# Alvey-Fairview Transmission Line Rebuild Project Final Environmental Assessment

Bonneville Power Administration  
DOE/EA-1891  
May 2014

This document provides changes made to the text of the Draft EA, as well as the comments received on the Draft EA and BPA's responses to those comments. The Draft EA, with the addition of these changes and the response to comments, constitutes the Final EA. The Draft EA is available on the project webpage at [http://efw.bpa.gov/environmental\\_services/Document\\_Library/Alvey-Fairview](http://efw.bpa.gov/environmental_services/Document_Library/Alvey-Fairview) or by calling 1-800-622-4520.

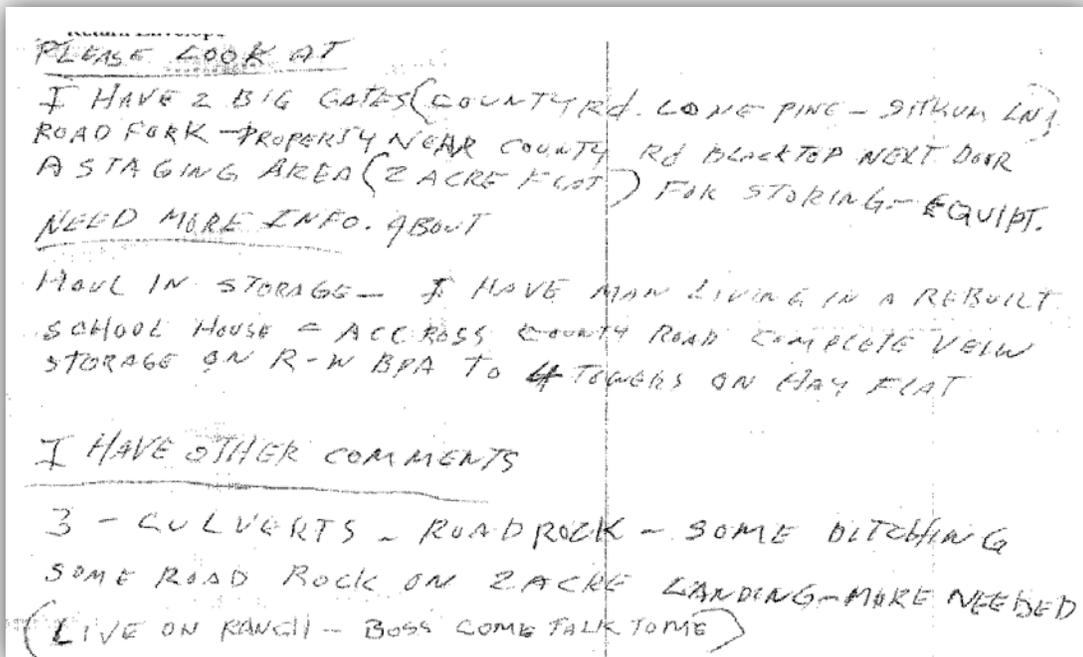
- 1) Gate at South Property line is falling apart and hard to operate.
- 2) Culvert that is existing, does not have enough cover to support heavy equipment.  
The two reconstruct roads leading up to 15/3 do not show culverts. This area is always wet, because of a spring, uphill, runs year around.
- 3) Acquire Access Road Easement.  
This is an existing dirt road, that is documented to exist in 1925 or before. That is before BPA Power Line Easement.

I need an explanation why BPA will not do what I have asked as part of the new easement agreement, yet requires me to exceed the county code - please respond.

Surface gravel will not support heavy equipment under rainy (wet) winter conditions. Once the road surface seal is broken by heavy equipment travel, water will enter the sub-grade. With no base rock the road will be damaged and a hazard will be created for heavy equipment and other vehicles traveling the road. I ask that BPA look at this section of road under heavy rain conditions. I will be glad to help digging test holes to show the lack of base rock. There are at least three locations that may have springs under the road, for they are very soft.

7) At the point the existing access road crosses the high pressure gas line, is there enough cover over the gas line for heavy equipment travel?

Thank you for your comment. The Alvey-Fairview Transmission Line Rebuild Project would not include work near the gate at the landowner's south property line, so this gate would not be replaced as part of the Rebuild Project. The rusted culvert C-015-002 identified by the landowner, as well as two other culverts on the property, C-015-003 and C-015-004, would be replaced or constructed as part of access road improvements for the Rebuild Project. These three culverts are accounted for in the numbers provided in Table 2-1 (page 2-3) in Chapter 2 of the EA, which lists the quantity of culverts that would be built or replaced as part of the Rebuild Project.

BPA proposes to obtain an access road easement for the road referenced in the comment letter leading up to structure 15/3. BPA plans on improving the road at its current grade but acknowledges the landowner's request to improve the road to Lane County standards. In discussions with the landowner (on March 1, 2014), BPA agreed to consider the landowner's requests for the road—crowning, culvert construction, and percent grade, as well as materials for the direction of travel portion of the road.
